Addendum assessment and decision No.06 for proposed modifications to M1 Western Distributor Smart Motorway Project

Modification to the M1 Western Distributor Smart Motorway Review of Environment Factors (REF).

Figure 1 - Tree ID#37 to be Removed, a Multi Stem (Trunk) specimen.

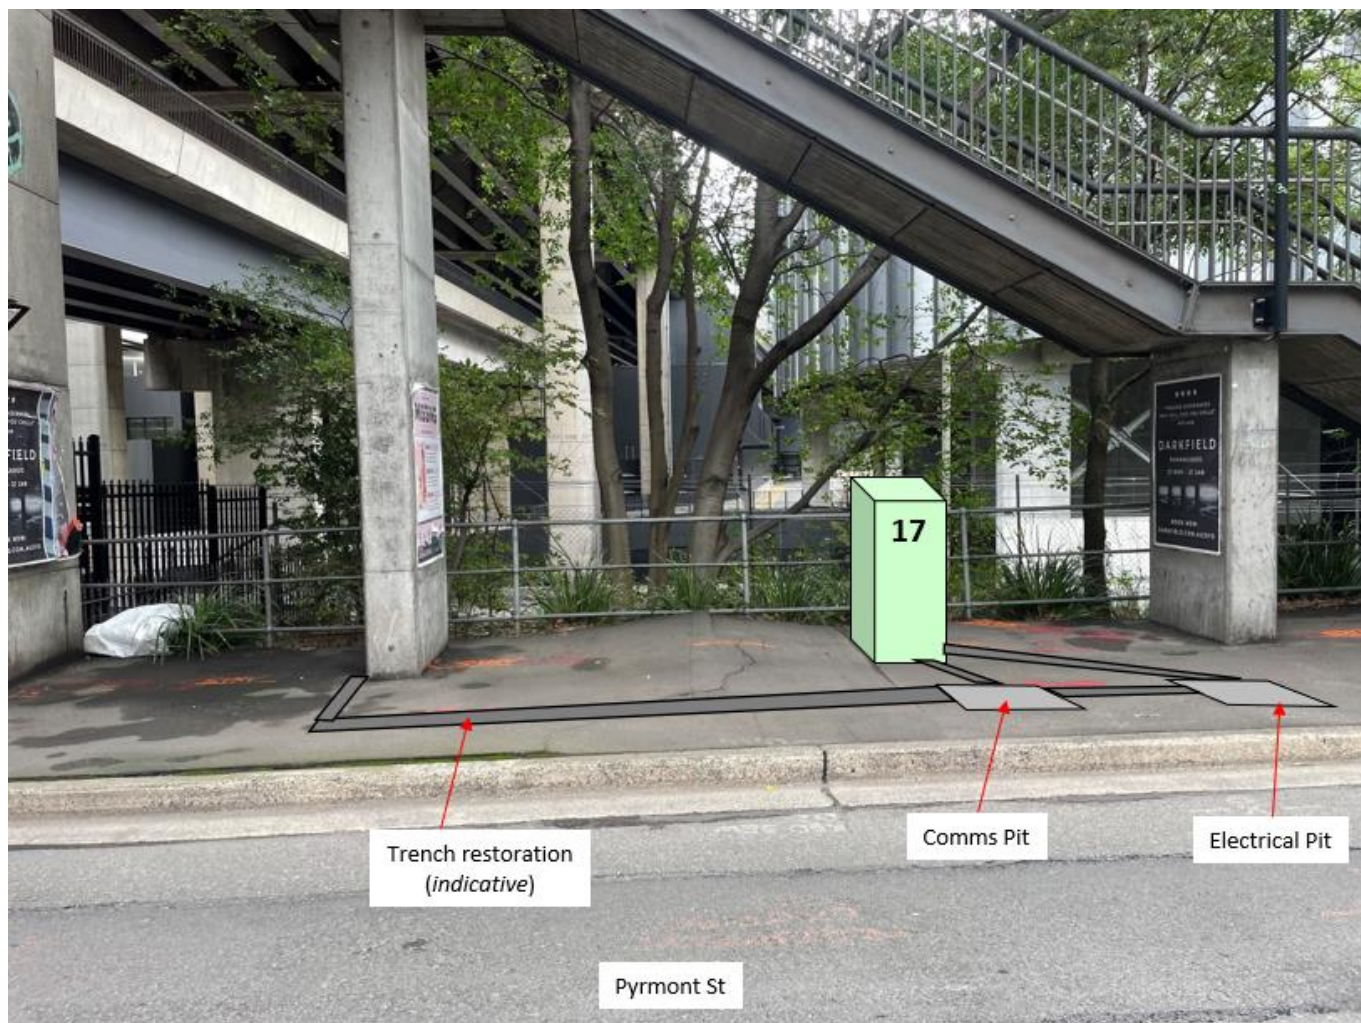
- Removal of one (1) additional semi-mature tree (Tree #37 -a specimen of *Celtis sinensis*) located within Placemaking NSW's land. This location is between Pyrmont Street and the Dulwich Hill light rail line (L1), shown in Figure 1.

Figure 3 - Approximate position of proposed RSC#17 under staircase in context with future-‘existing’ RSC#14

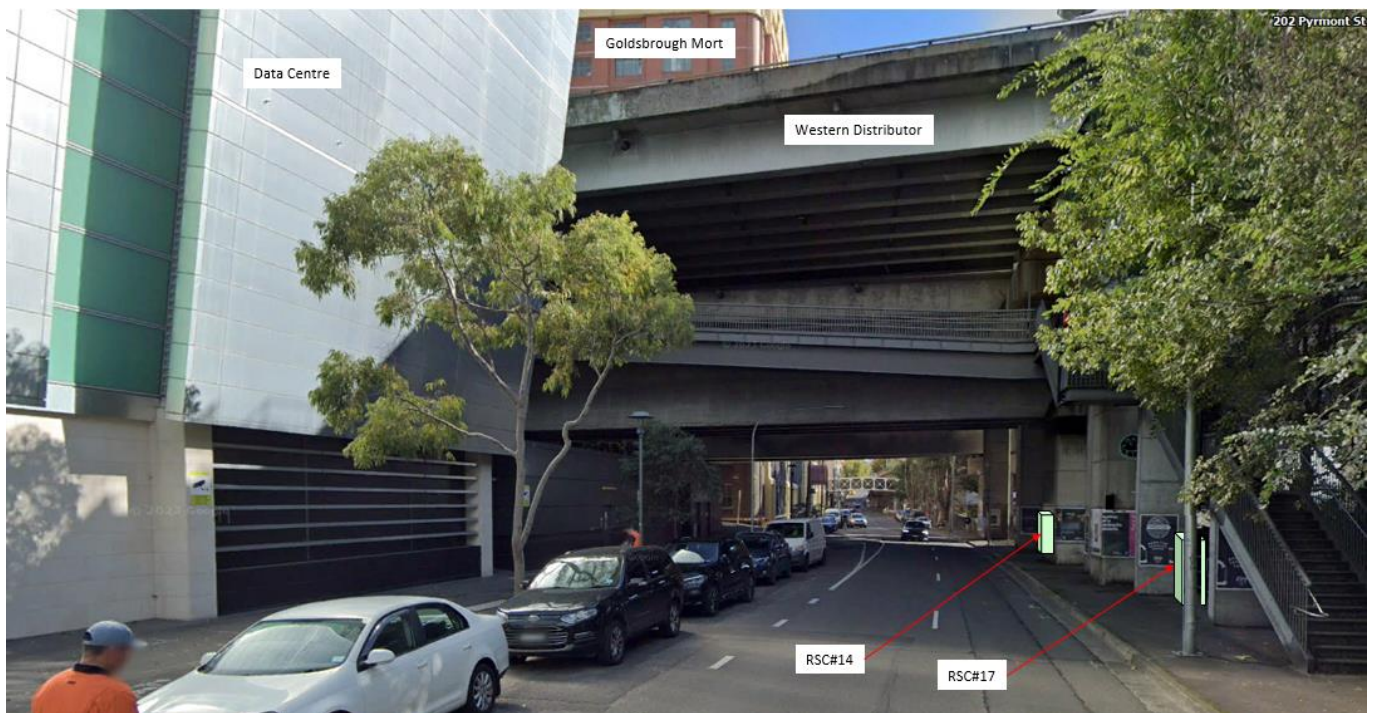
- Installation of RSC#17 with associated electrical and communications pits and underground conduits on the eastern footpath of Pyrmont Street beneath the existing stair case which connects Pyrmont Street and the Western Distributor footway, Figure 2 and Figure 3, and Figure 4 of Appendix D.

Figure 5 - Approximate position of proposed RSC#16 in context with future-'existing' RSC#15

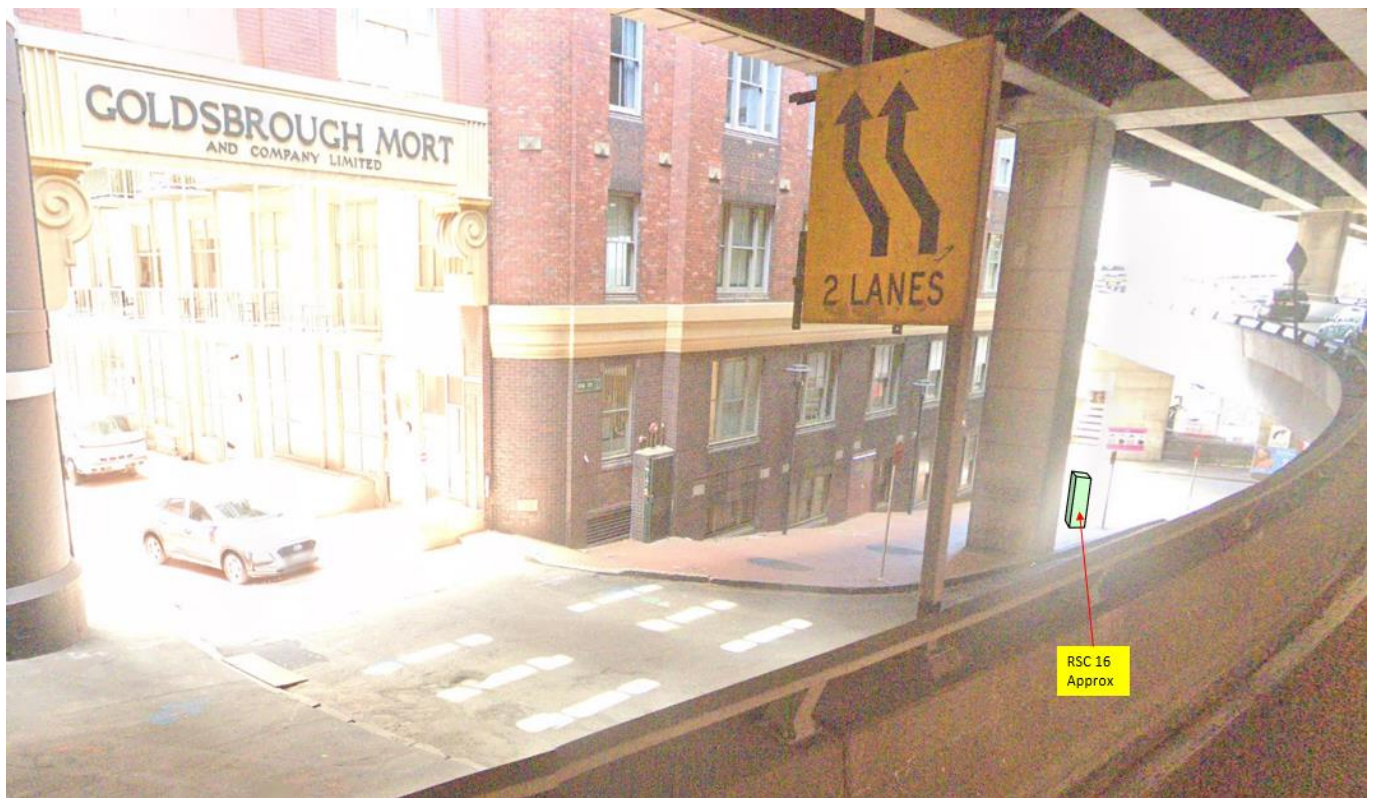
- Installing RSC#16, and associated electrical and communications pits and underground conduits on the footpath adjacent Goldsbrough Mort Building near Pyrmont St as illustrated in, Figure 5, and Figure 6 of Appendix D.

Figure 7 – Relative position of roadside cabinets 14 and 15, compared to newly proposed position of roadside cabinets 16 and 17.

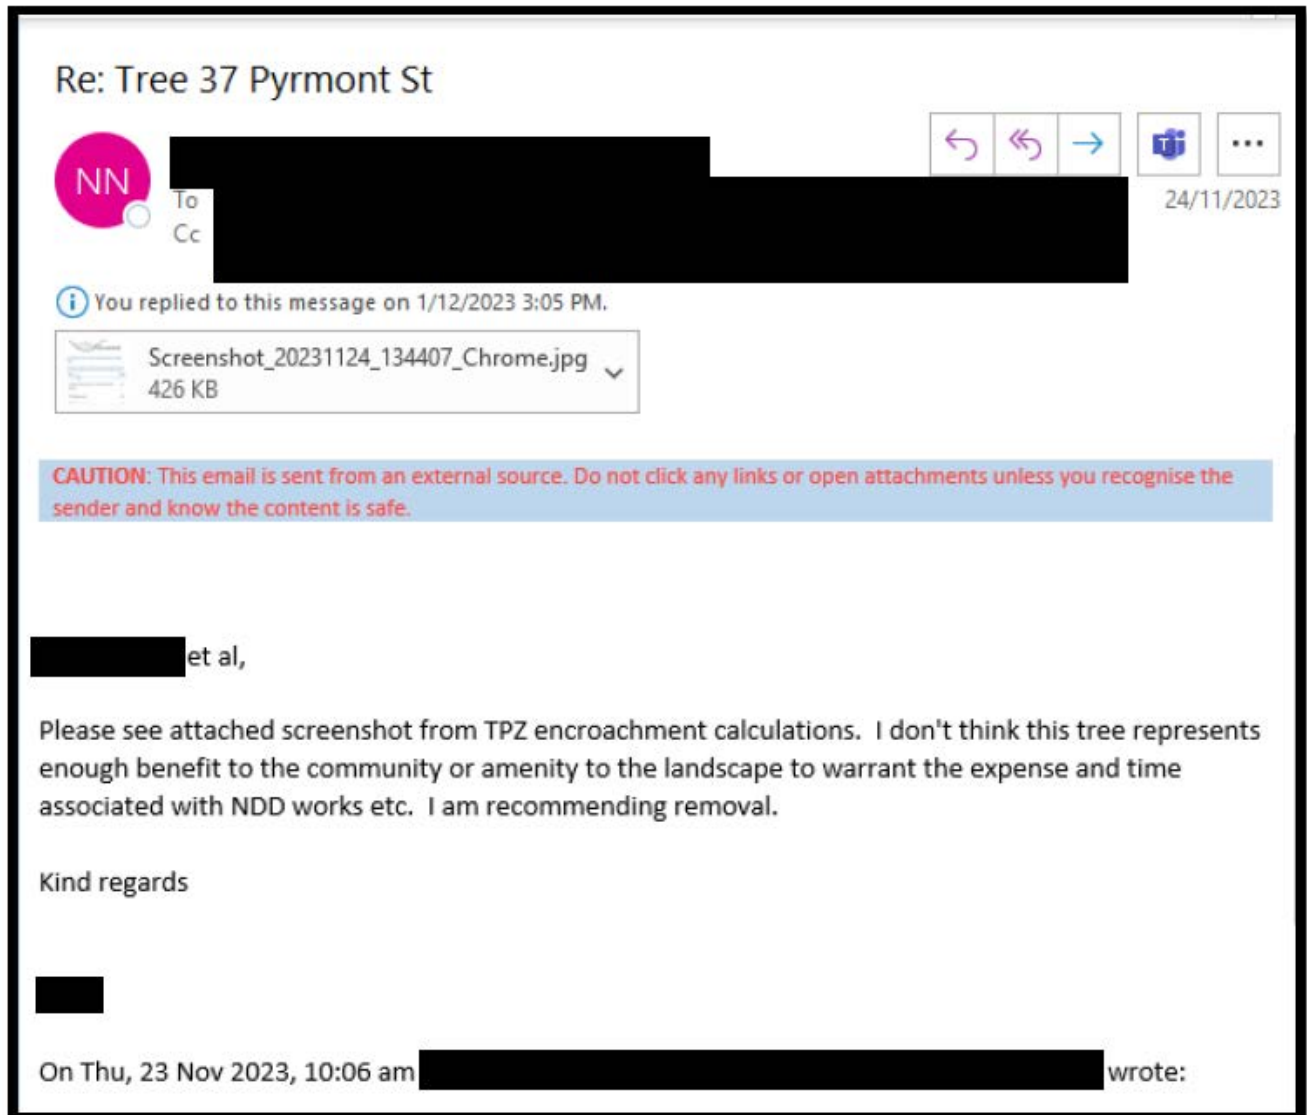
The approximate position of roadside cabinets #14, #15, #16, and #17 as per this proposed modification are shown in Figure 7,
